PLANNING ANALYSIS AND RECOMMENDATION

Recommendation: Approval with Condition

09-113CDDS
Corridor Development District Sign
Shoppes at River Ridge - Montgomery Inn
4565 West Dublin-Granville Road

PROPOSED SIGN

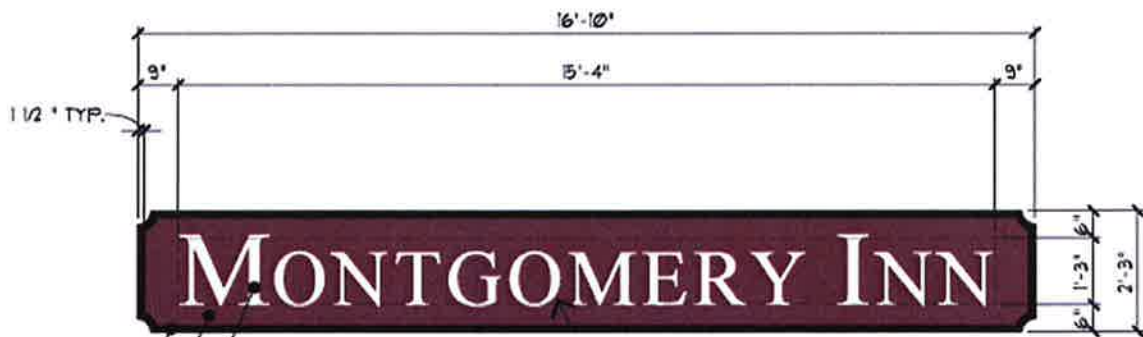
- **Dimensions:** The proposed sign is 2 feet, 3 inches in height and 16 feet, 10 inches in width to be installed 13 feet from grade centered over the main restaurant entrance, which meets Code and the approved sign plan.

- **Area:** The proposed sign is 38 square feet on a 36-foot-wide tenant frontage. When combined with the existing 50-square-foot sign, the total sign area would exceed the maximum area of 80 square feet permitted by Code.

- **Colors & Design:** The proposed sign colors include white lettering (*Sherwin Williams Pure White*) with a red background (*Sherwin Williams Rookwood Red*) and a black border (*Sherwin Williams Tricorn Black*), which will coordinate with the colors used on the existing sign and the approved sign plan. The proposed font is different from the existing sign, and no logos are proposed; however, the font design will coordinate with the design of the existing restaurant.

Condition: That the total area for the two signs be limited to a maximum of 80 square feet.

SIGN ELEVATIONS

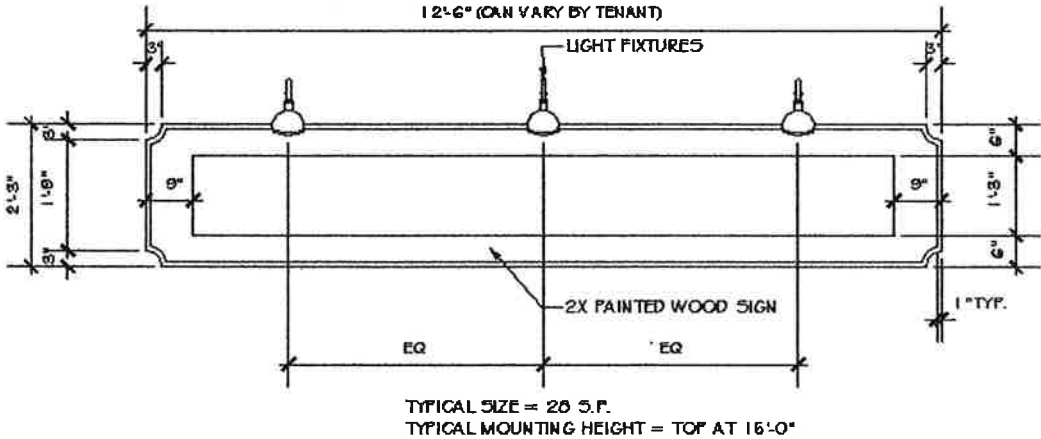
While the existing sign faces Riverside Drive, the view to the sign from the road is limited due to the severe grade change between the road and the building. The applicant is requesting a second, 38-square-foot sign facing east toward the rest of the Shoppes at River Ridge, which will help identify the building for pedestrians and vehicles inside the shopping center.

- **Number:** The sign plan for the Shoppes at River Ridge permits one sign per tenant. Approval of the proposed sign would allow the Montgomery Inn restaurant (Building D) an additional sign, which is appropriate given the building's double frontage on both Riverside Drive and the shopping center.
